City of Portland, Maine – Building or Use Permit Application 389 Congress Street, 04101, Tel: (207) 874-8703, FAX: 874-8716

BUILDING PERMIT REPORT

DATE: 24 July 99 ADDRESS: 15 Central Ave. P.I. CBL: 087-HH-064
REASON FOR PERMIT: To Amend Permit # 991426 (deck & porch)
BUILDING OWNER: Roman Catholic Church
PERMIT APPLICANT: William White, Inc Contractor
USE GROUP A-3 CONSTRUCTION TYPE 5B

RE: St. Christopher's Church
Peaks Island

Existing Church

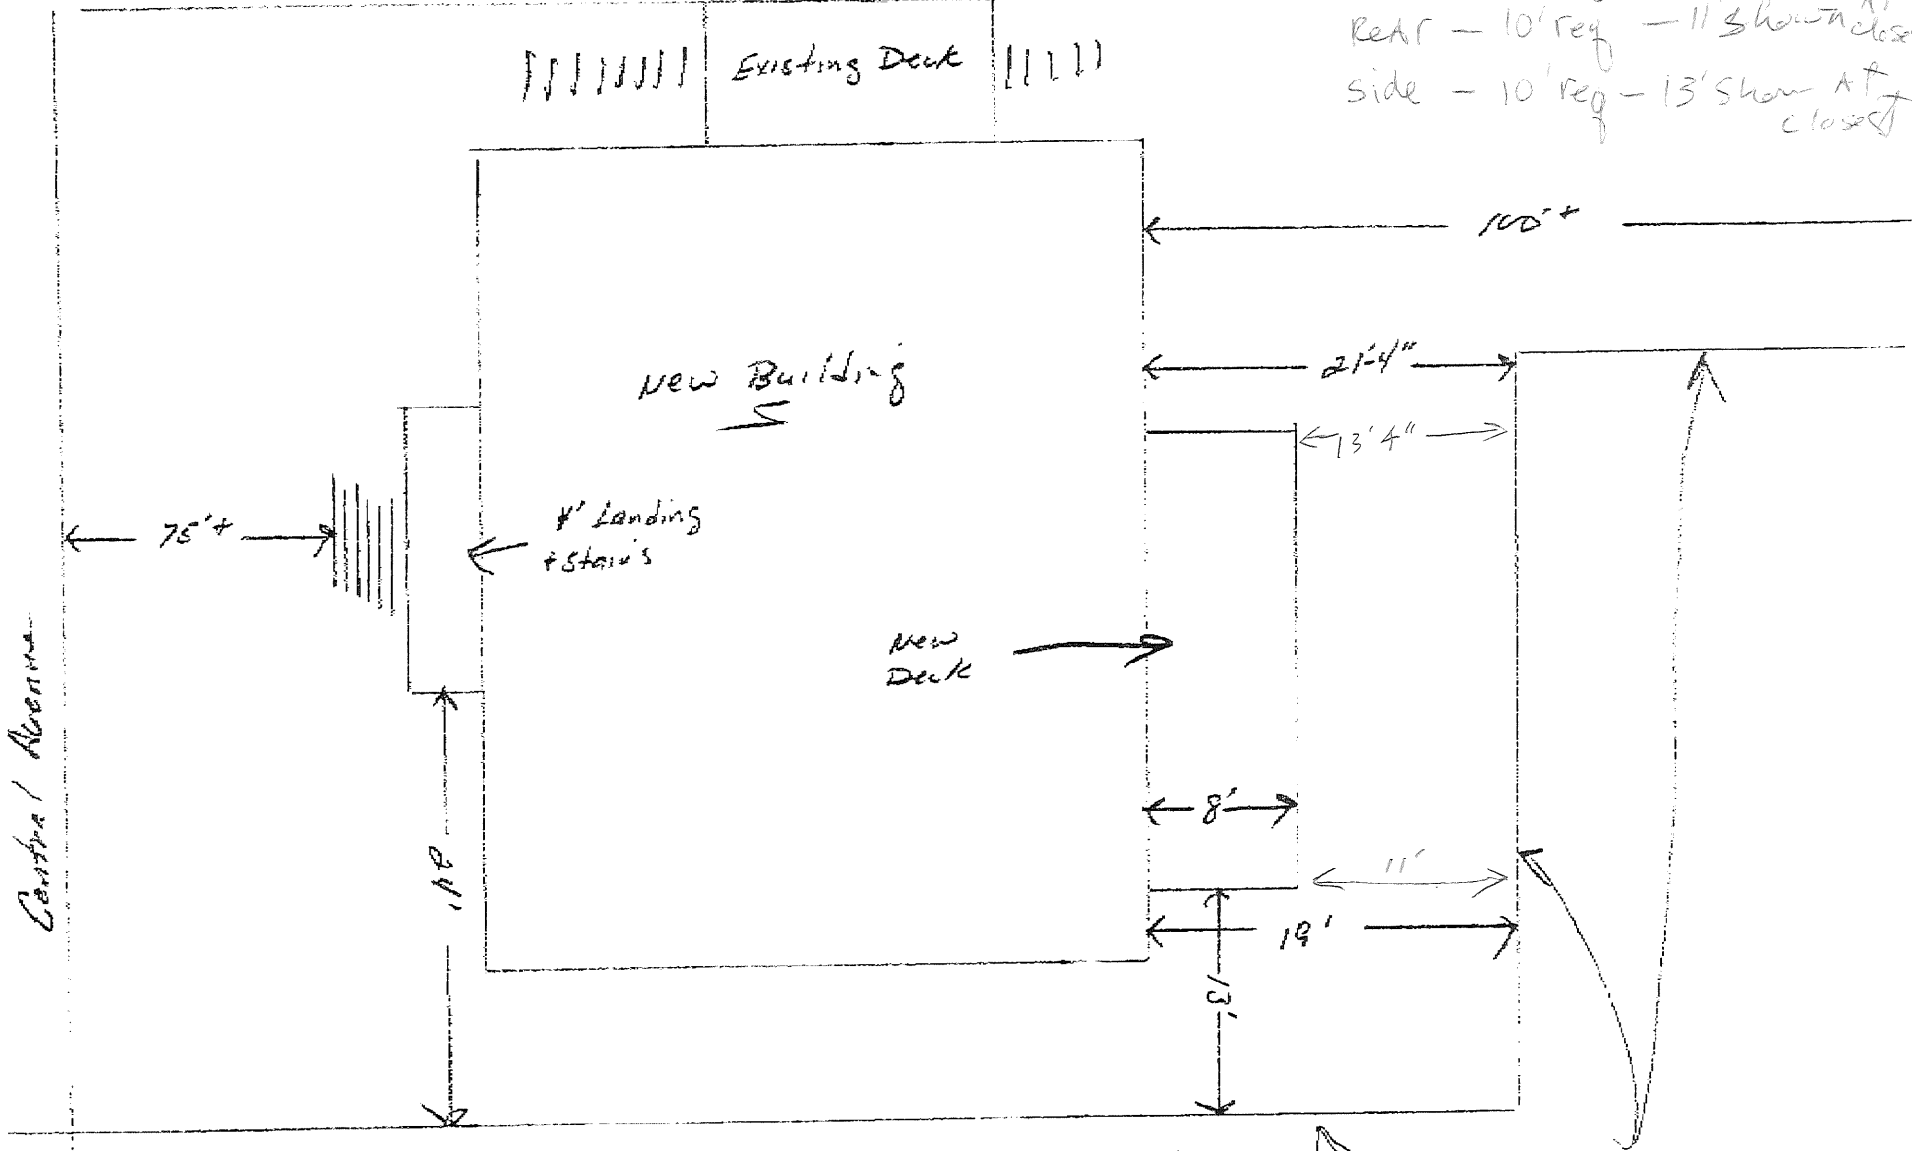
I-B Zone - zone
see origin of sheet
with orig. permit

Front - 20' req - 75' shown
Rear - 10' req - 11' 3/4 shown at closest
side - 10' req - 13' shown at closest

Rear Deck

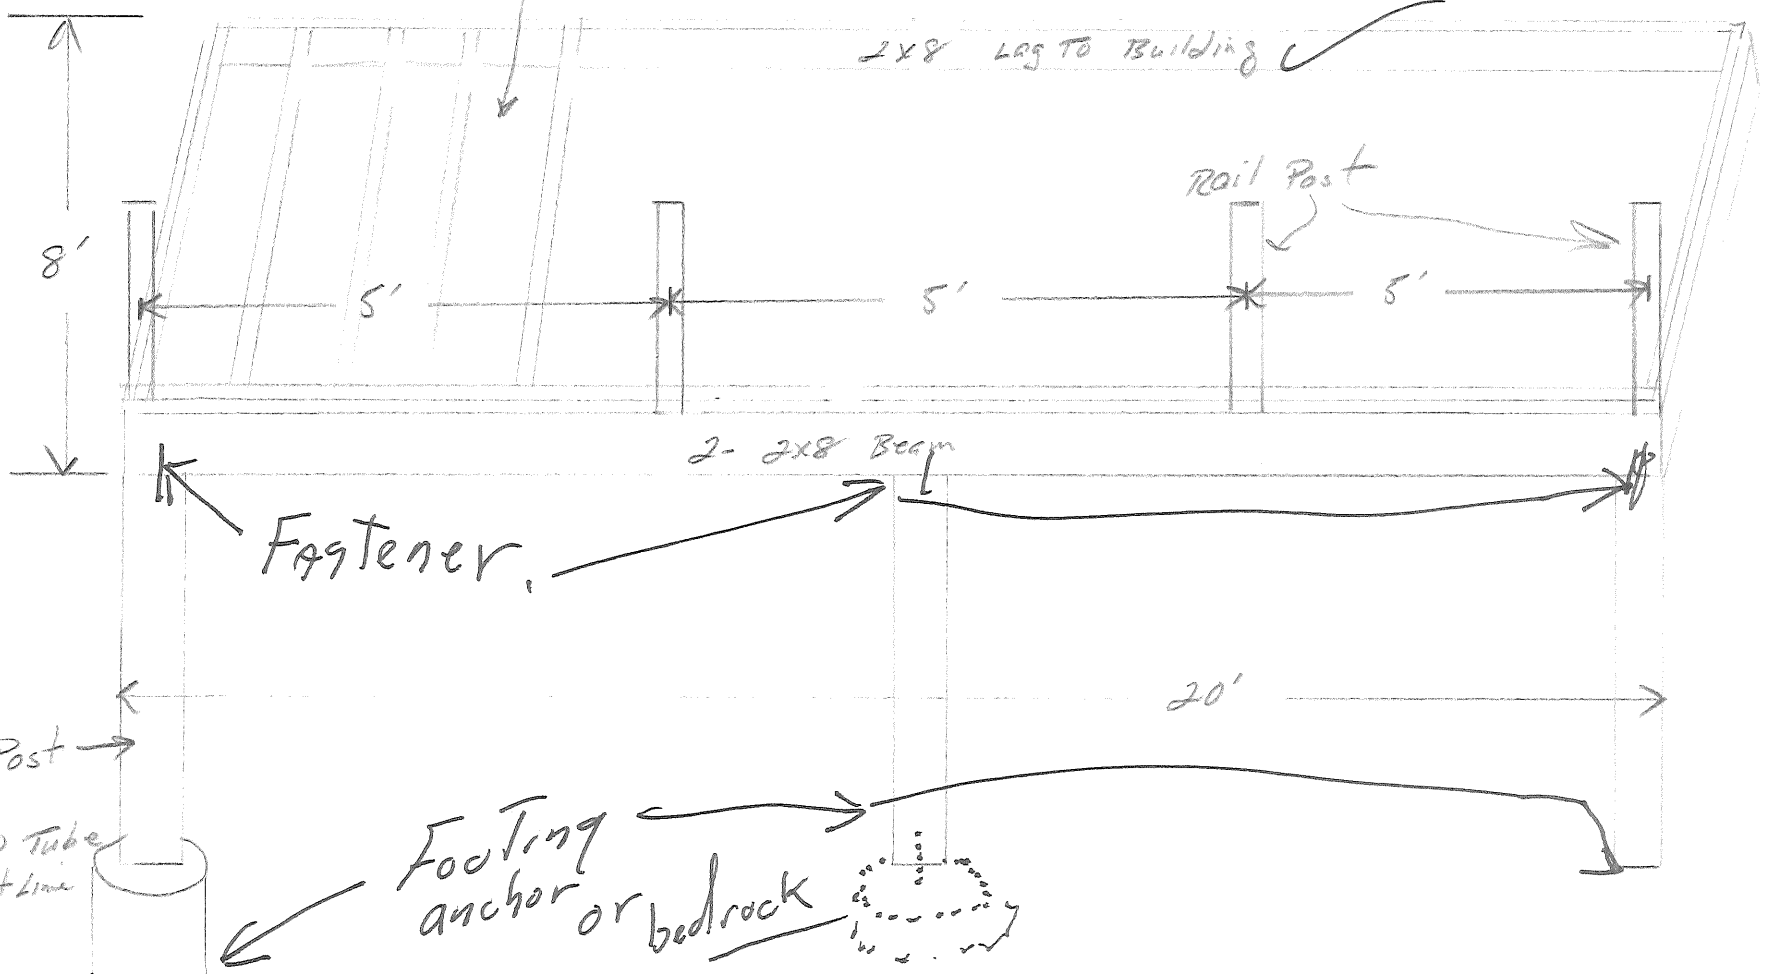
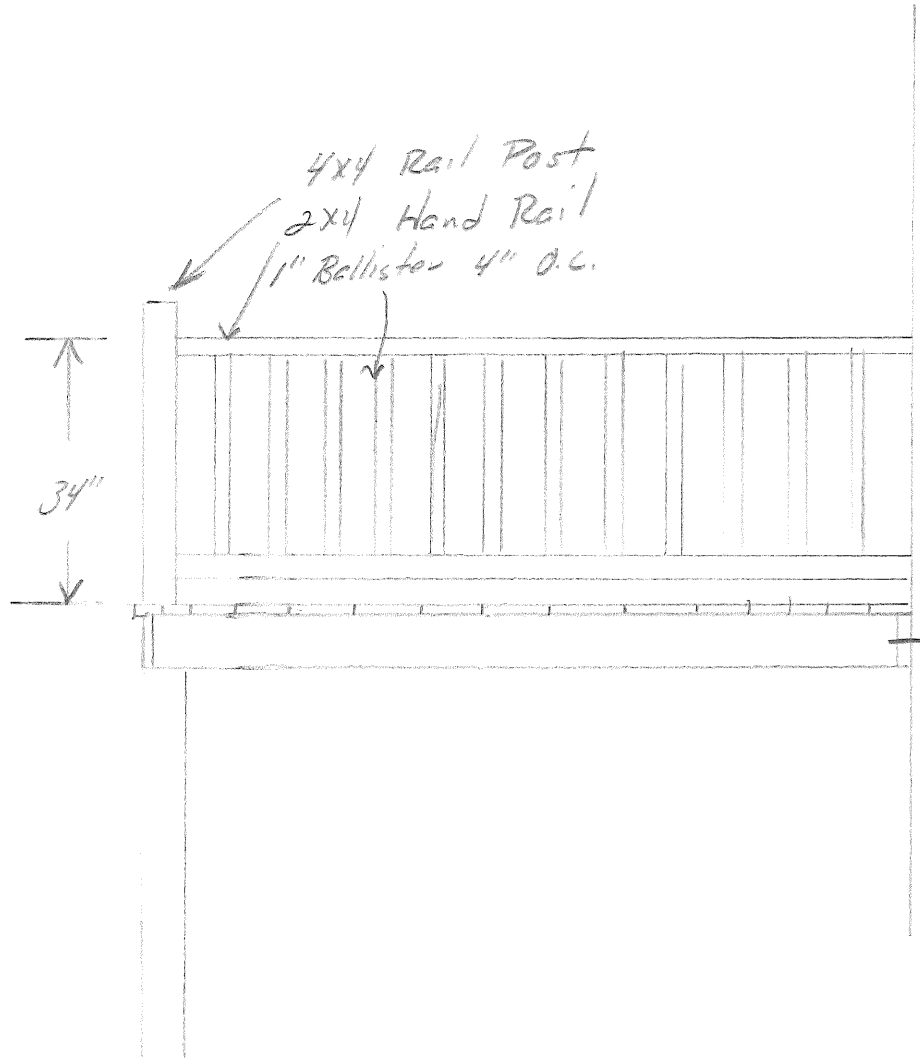
— SAM? - MARKS

- X 35. Anchors shall be used between footing and piers (5020 Tubes)
- X 36. Fasteners shall be used between piers (5020 Tubes) and wood framing.
37. _____
